RS-09-118

Braidwood Station, Units 1 and 2
Facility Operating License Nos. NPF-72 and NPF-77
NRC Docket Nos. STN 50-456 and STN 50-457

Subject: Submittal of Relief Requests Associated with the Third Inservice Inspection Interval

M-68, SHEET 7 (UNIT 1)
AND
M-140, SHEET 6 (UNIT 2)

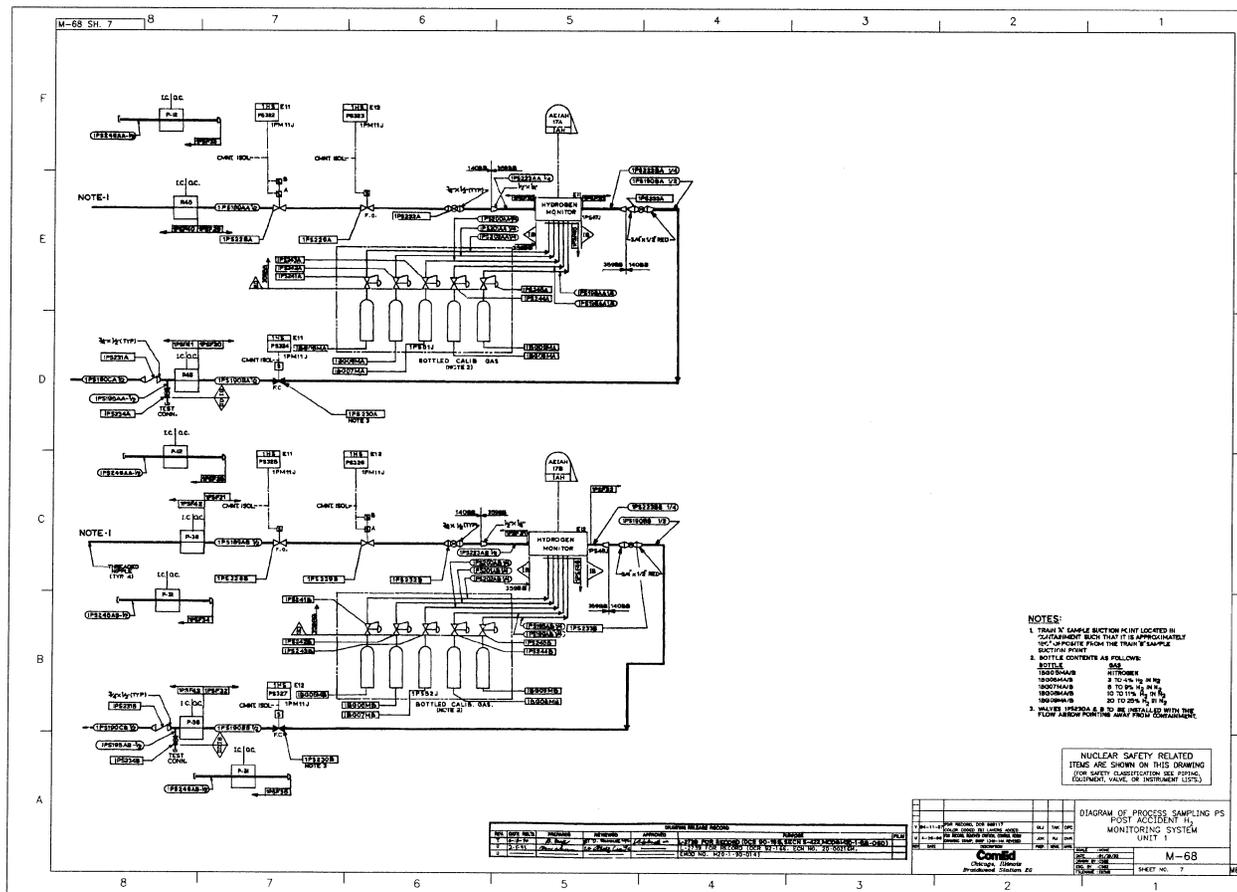
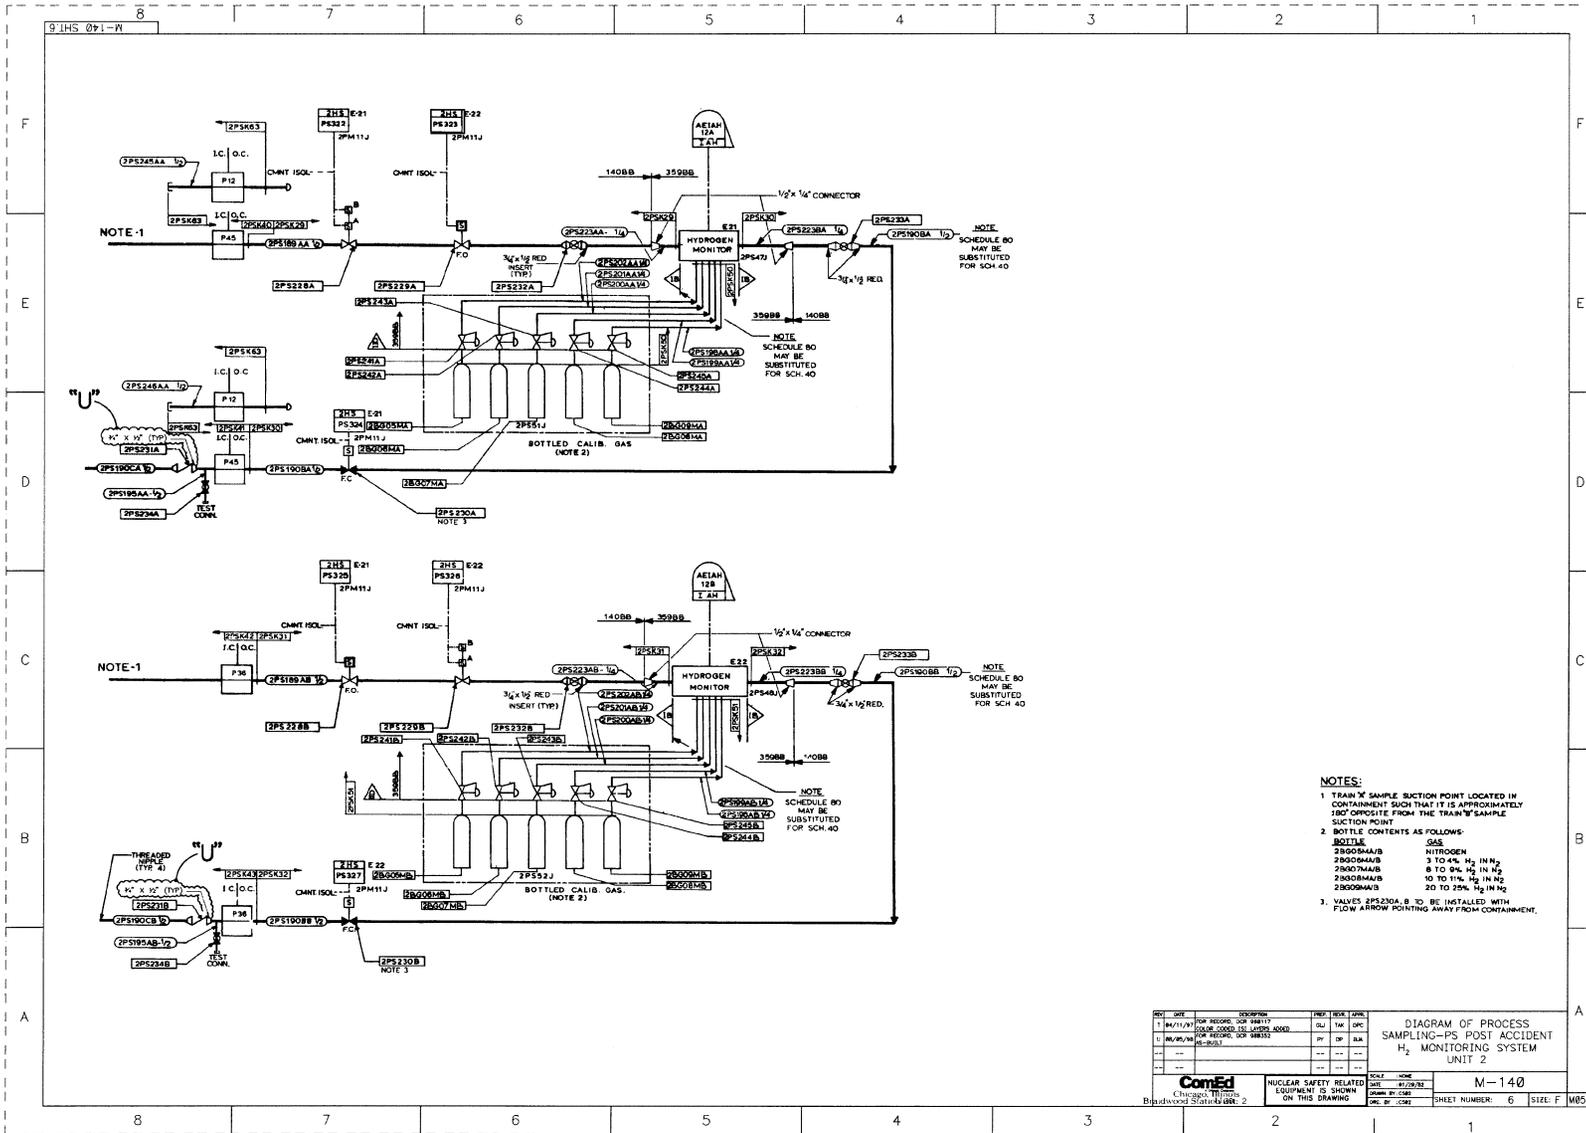
Code Class:	2
Reference:	IWC-5200, "System Test Requirements"
Examination Category:	C-H
Item Number:	C7.10
Description:	Alternative Method for Pressure Testing Unit 1 and Unit 2 Post Accident Hydrogen Monitoring System Piping, Process Sampling (PS) System Piping
Component Numbers:	ASME Section XI Class 2 Piping Outside of Containment Between Valves 1(2)PS228A(B) and 1(2)PS230A(B). (Reference Drawings M-68 Sheet 7 (Unit 1) and M-140 Sheet 6 (Unit 2) provided in Attachment 2)

The specified piping serves as the supply flow path from the containment to the Hydrogen Monitors via 1/4" tubing connections and the return flow path from the Hydrogen Monitors (via 1/4" tubing connections) back to the containment. The system medium is air. The system is comprised of two separate trains for each unit. The subject piping is 1/2" NPS (nominal pipe size) and/or 1/4" stainless steel piping/tubing (SA 312 TP 304 pipe along with SA 213 TP 304 or 316 tubing). The system design pressure is 60 psig. The approximate length of piping/tubing per train (supply and return piping combined) is 275' for 1A, 225' for 1B, 245' for 2A, and 185' for 2B. The nominal system operating pressure ranges across the system from vacuum on the suction piping to a maximum of 10 psig at the pump discharge, which decreases for the remainder of the piping. In the past, the piping was tested by pressurizing the volume and then performing a soap bubble or "snoop" test on all welds and piping. During the review of surveillance results in 2005, Braidwood Station determined a portion (approximately 50' of supply and return piping combined) of the piping on the 1A train is located in a pipe tunnel and is physically inaccessible for VT-2 visual examination due to the close proximity of adjacent piping and the pipe tunnel wall. Due to the interferences and congestion in the area, the examiner could not physically get close enough to the associated piping to apply the soap bubble solution necessary to meet the IWC-5210(b)(2) requirements for the method of detecting and locating through-wall leakage when gas is the pressurizing medium. The use of an ultrasonic sound gun was considered for the inaccessible piping, but the obstructions surrounding the area of interest significantly reduce the ability to detect and pinpoint a leak.

In addition to the limitations associated with the 1A train, for all trains there are significant portions of the piping outside the pipe tunnel located at upper elevations (approximately 30 feet above the floor) where the performance of the VT-2 visual examination using soap solution creates a personal safety hazard. In order to meet the Code requirements for the examination, the examiner must perform a hand over hand walk down while using fall protection along with a retractable lanyard to get close enough to the piping to apply the soap bubble solution and perform the VT-2 visual examination required by ASME Section XI. Due to the congestion from other piping in the area, scaffolding cannot be erected to provide access to the piping.
